GNRO-2002/00054

SUBJECT: Grand Gulf Nuclear Station, Unit 1
Docket No. 50-416
Response to Requests for Additional Information, Part 2
Appendix K Measurement Uncertainty Recovery – Power Uprate
Request (TAC MB3972, GGNS LDC 2002-074)

Response to NRC RXS Branch RAI for GGNS Power Uprate

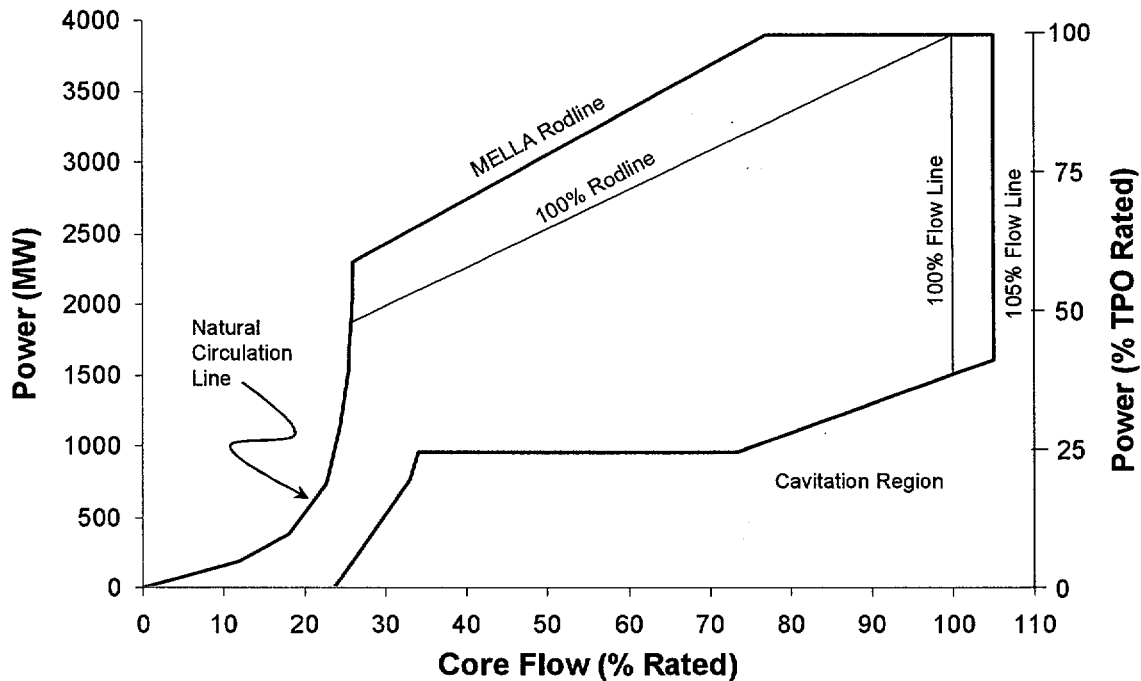
- 6(a). On Figure 1-1, please identify the Rod Lines.

- 6(b). This map is different from the typical power/flow map showing the cavitation area, natural circulation area, MELLA line, etc. Please submit the standard power/flow map. What is the significance of the formula starting with RL? What is RL?

The submittal reported the rod line equation in lieu of the actual rodlines. The MELLA and 100% rodlines are illustrated in the figure below.

The TPO power/flow map is re-drawn below identifying the typical areas of interest. Consistent with NEDO-32938, the absolute upper flow rodline is unchanged with TPO. The power/flow map in the submittal included the rod line equation used to determine the rodline associated with any combination of power and core flow where:

RL = rodline (%),
P = power (%), and
 W_T = core flow (%)
